TO : All Bidders  
FROM : George M. Wiens  
PROJECT : CTE Classroom Addition  
Vista Murrieta High School  
1615400.41  
SUBJECT : Addendum 2  
DSA : 04-115755 / 33-H18

Addenda No. 2 – Scope of Work Questions

1/4" = 1'-0" 12

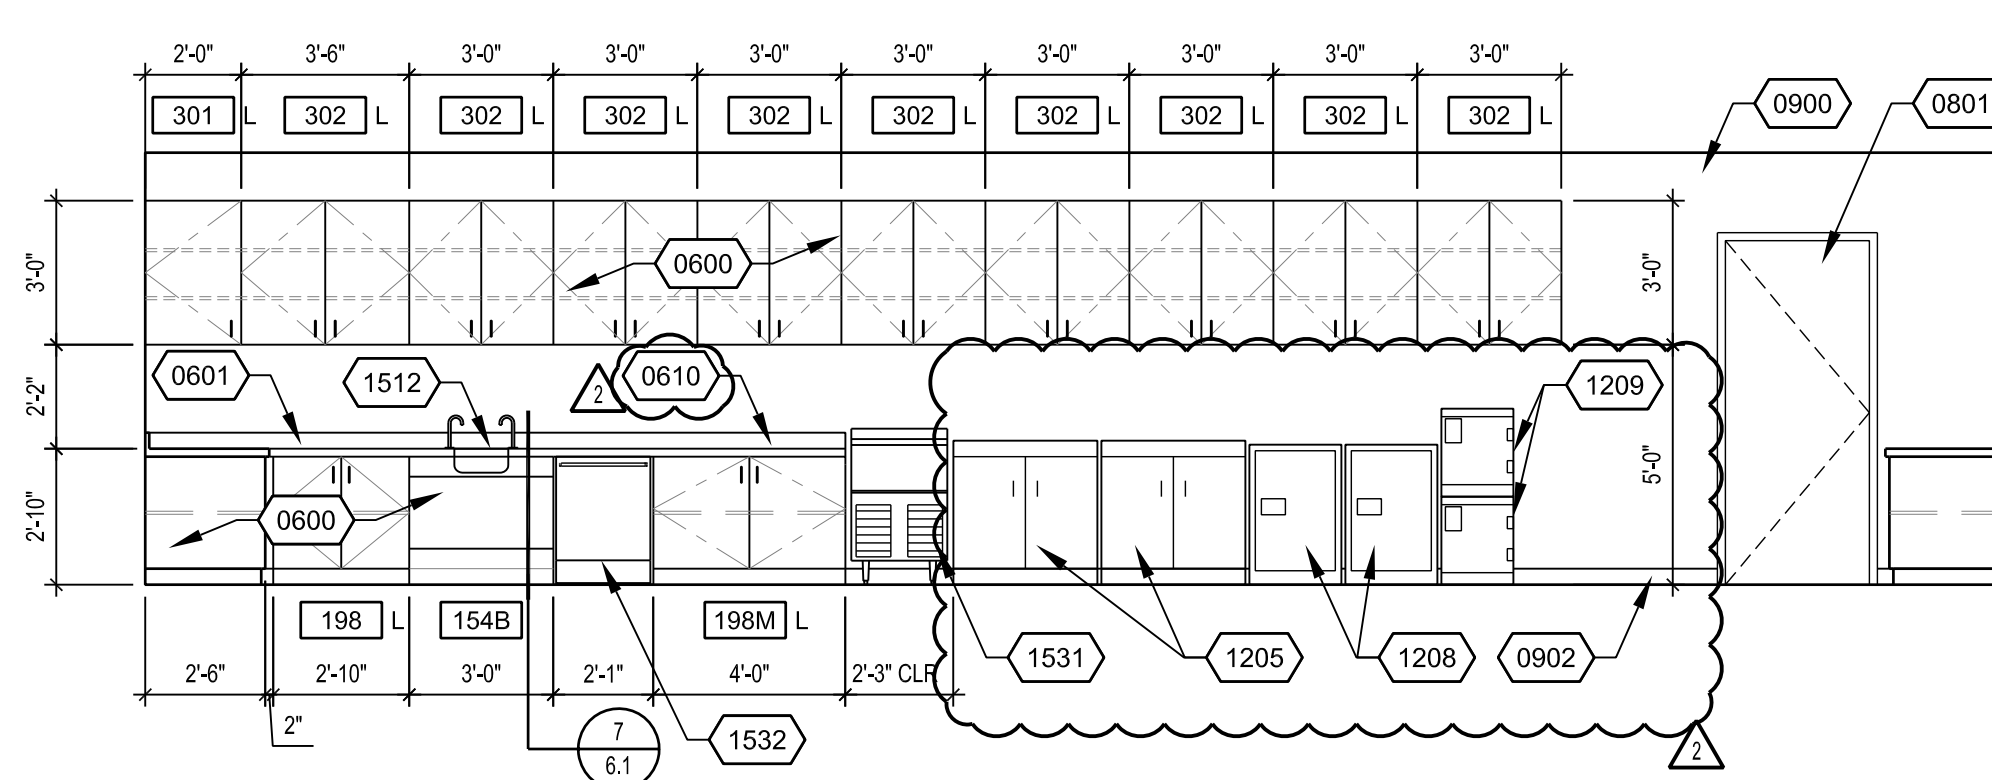
- A. Revise as indicated in the clouded area labeled Delta 2 on the attached AW7.2.

DETAILS  
DRAWING NUMBER: **M4-2**

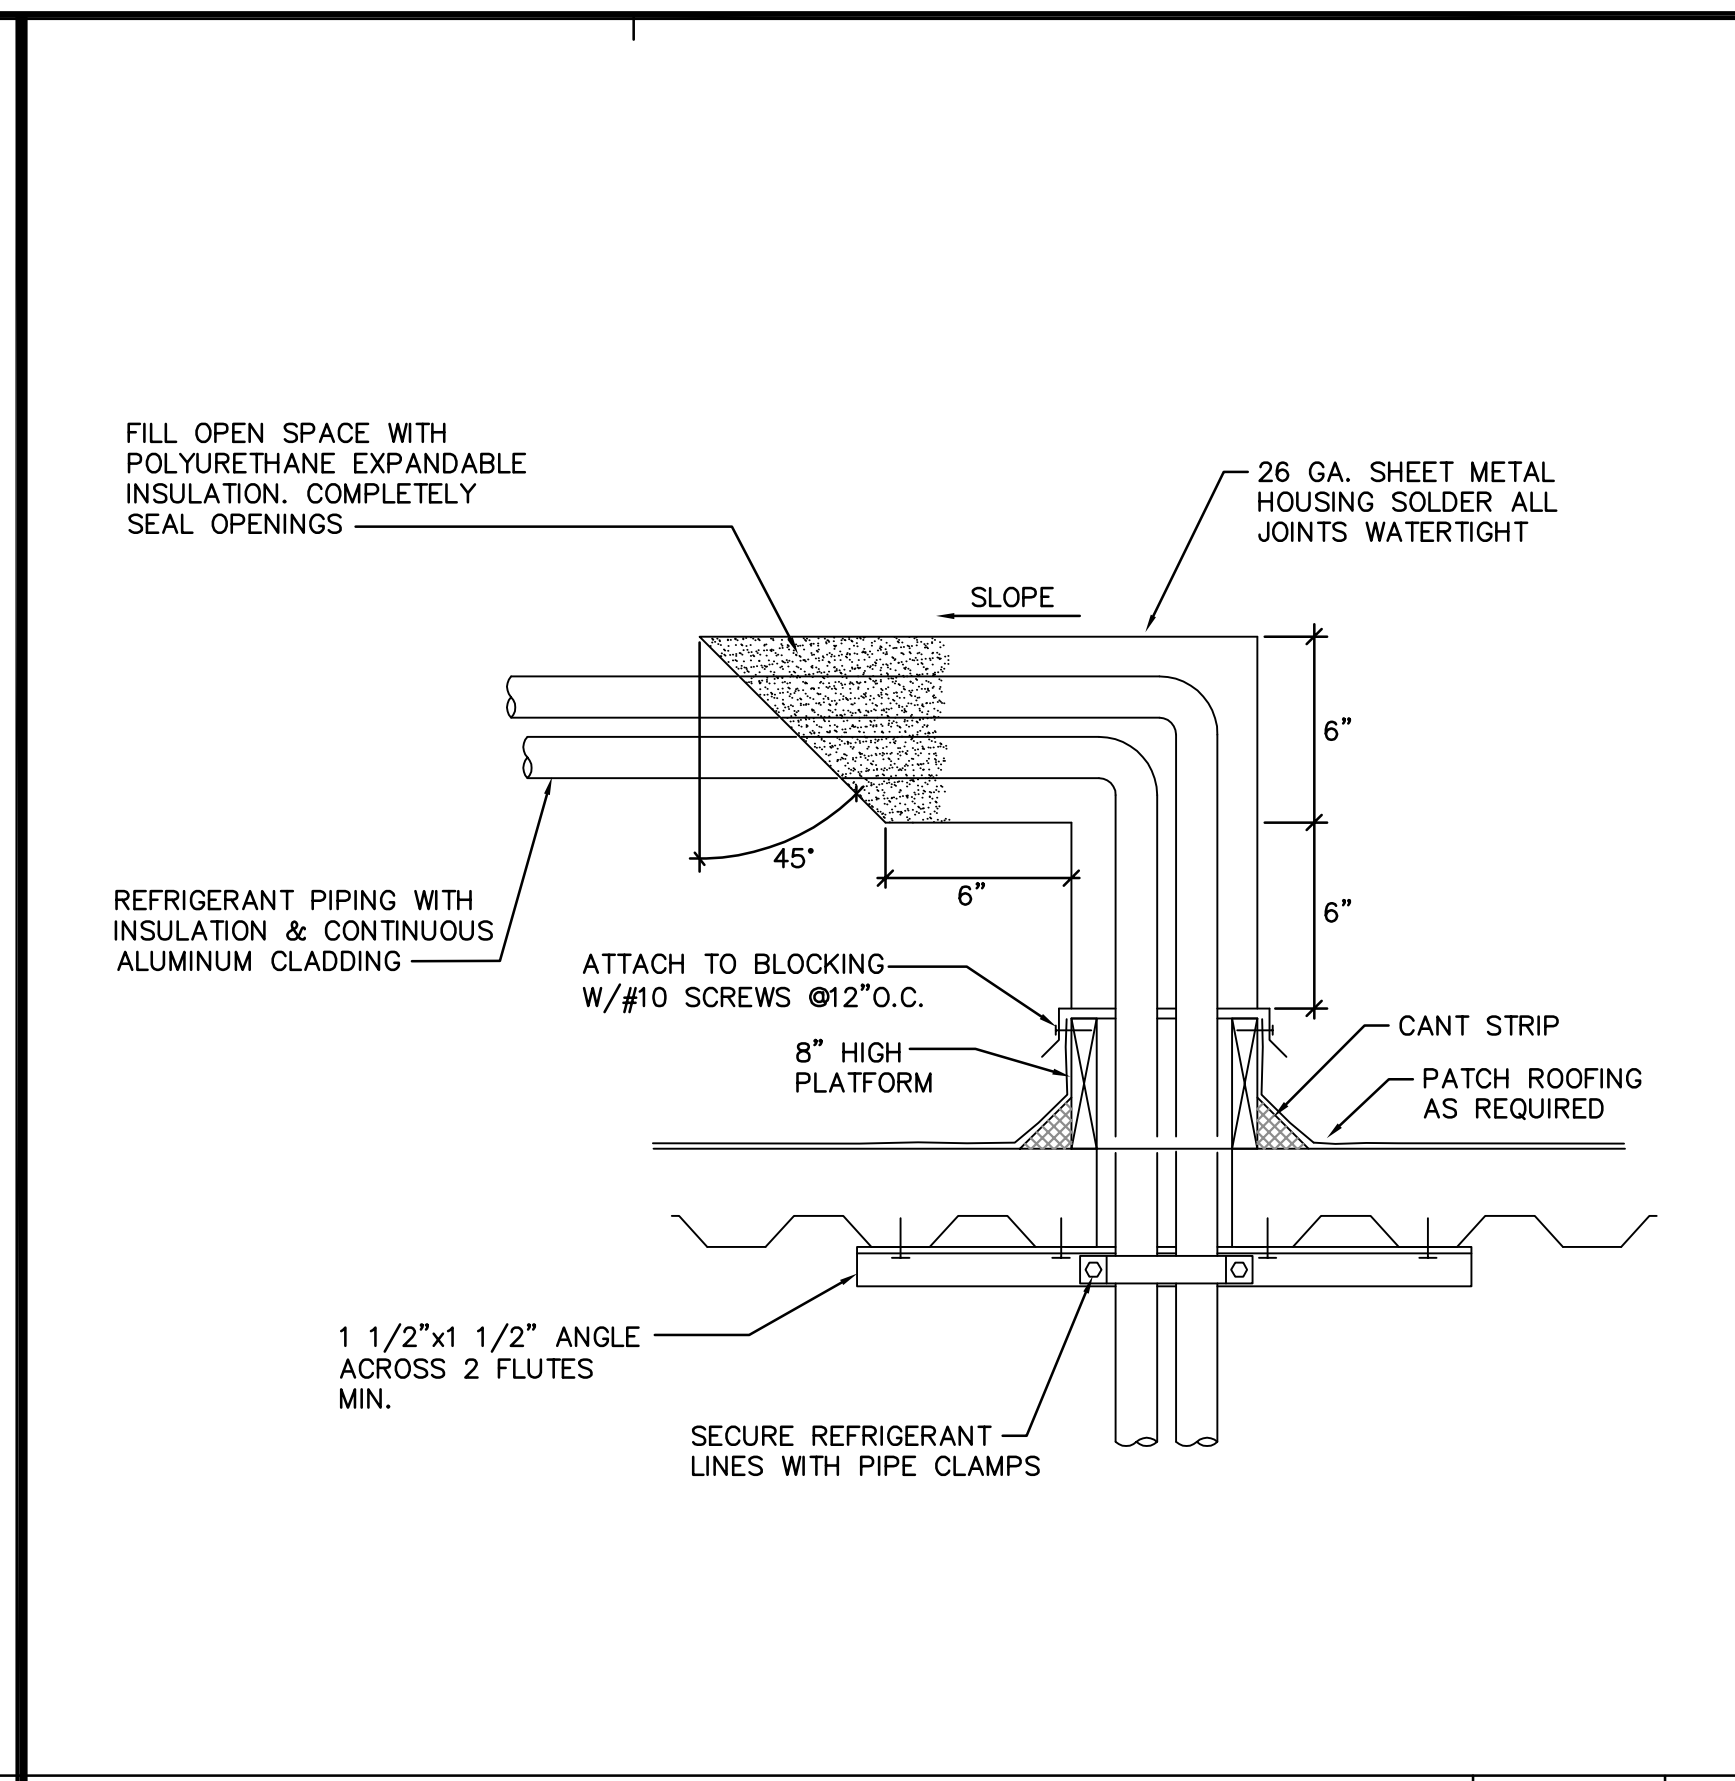
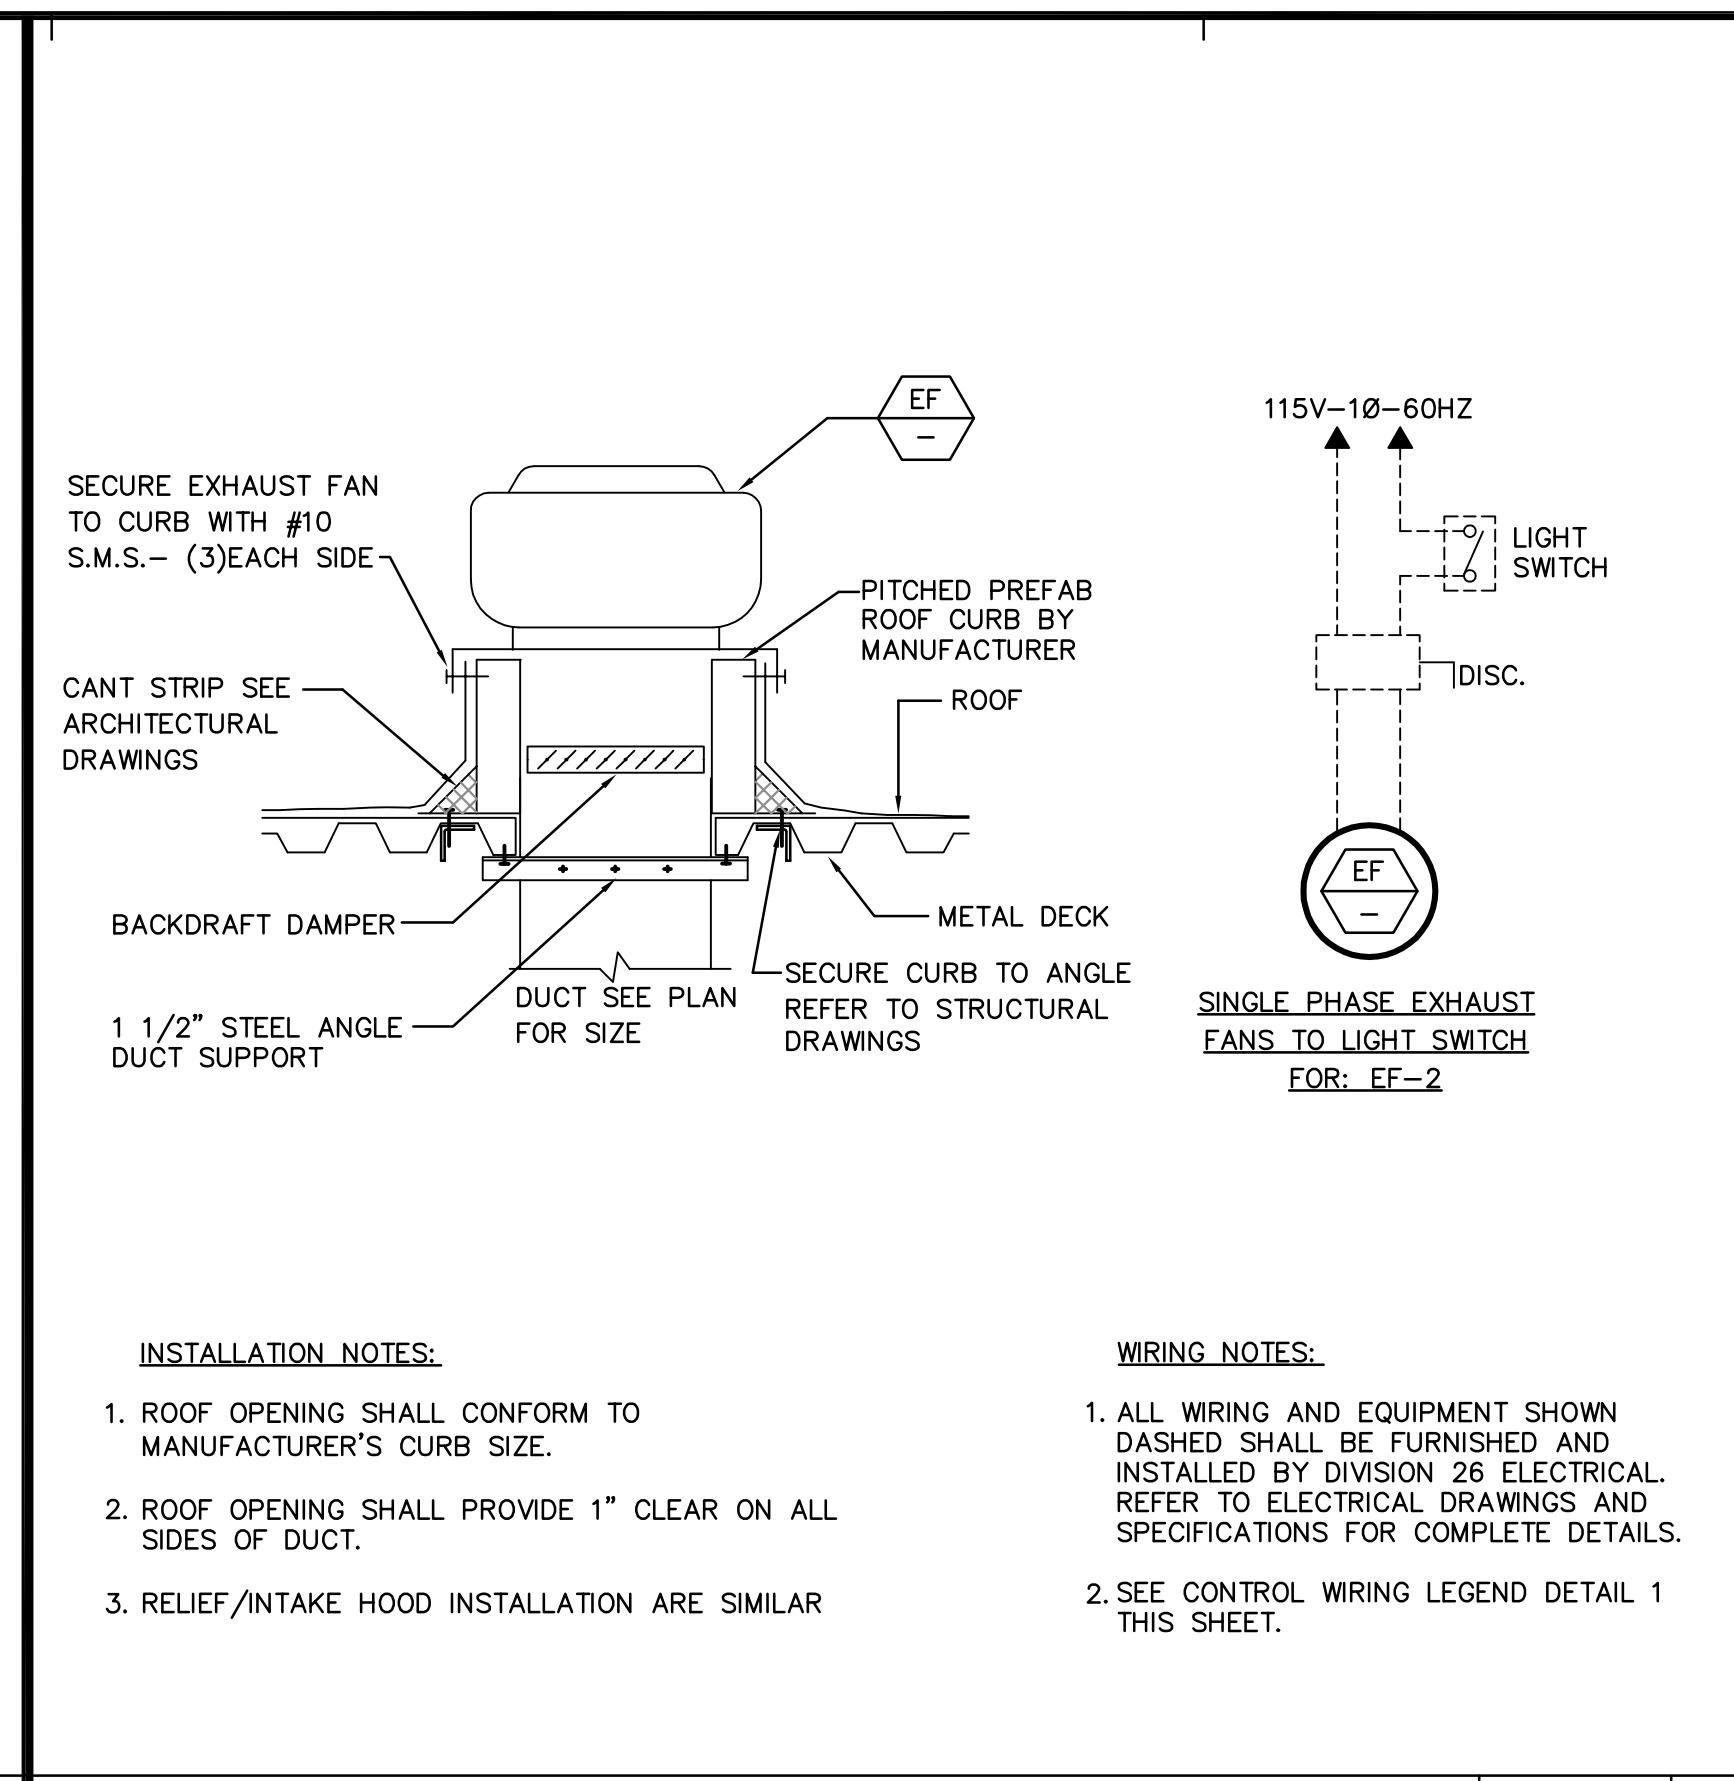
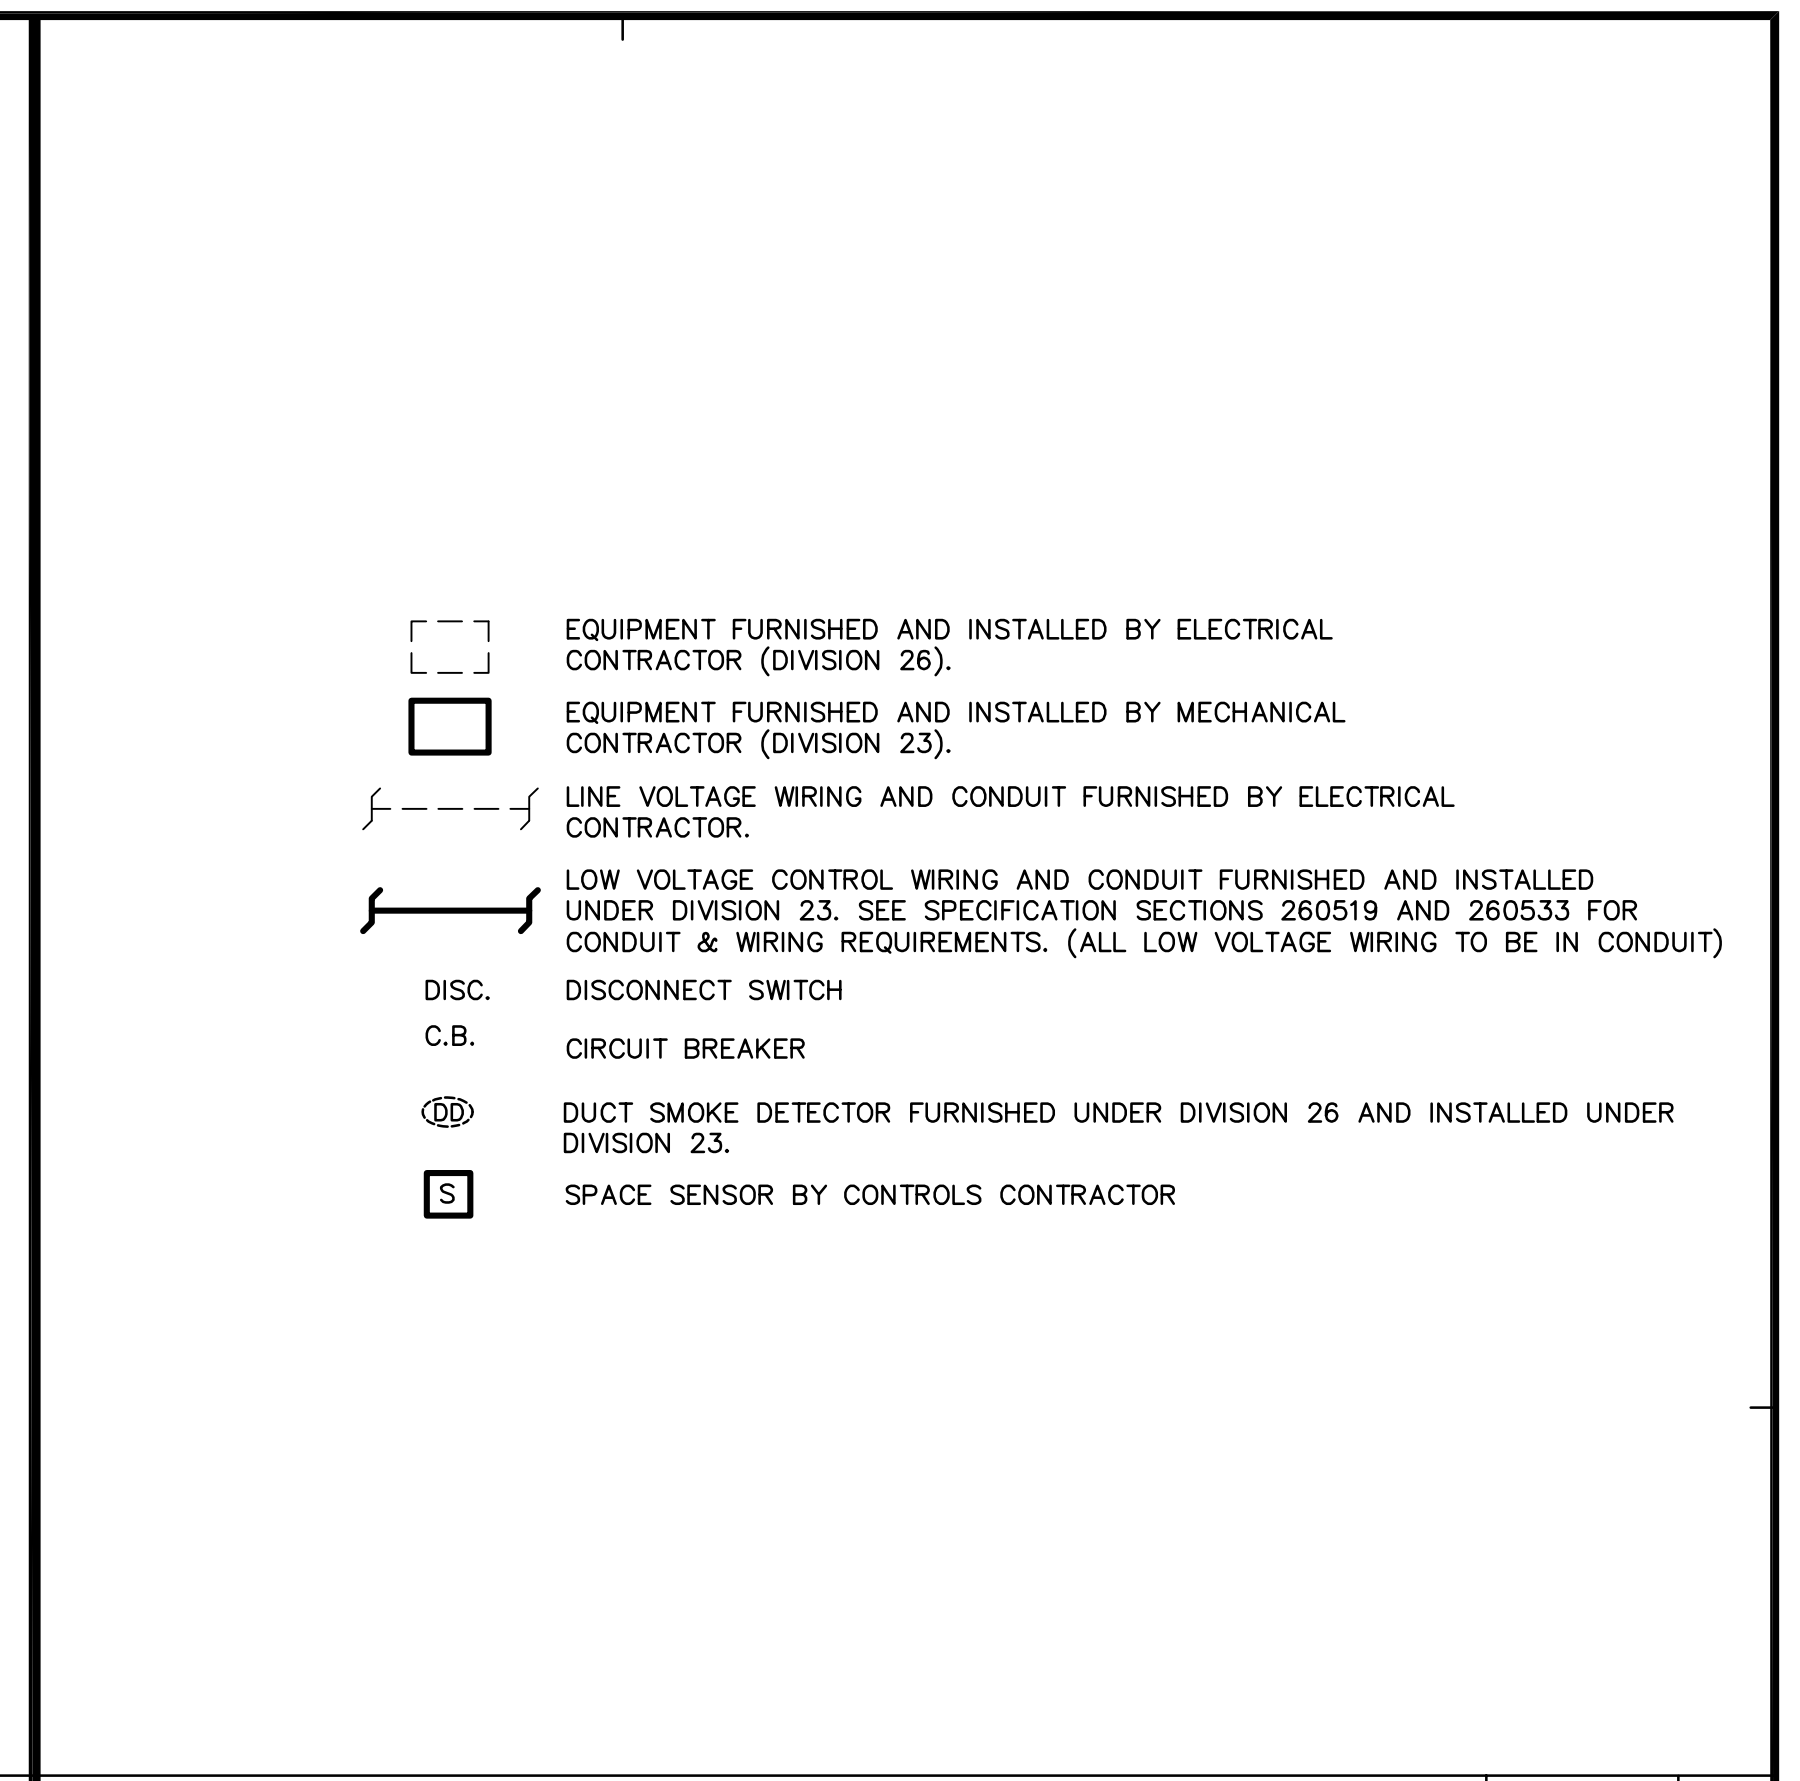
- A. Revise as indicated in the clouded area labeled Delta 2 on the attached M4.2.
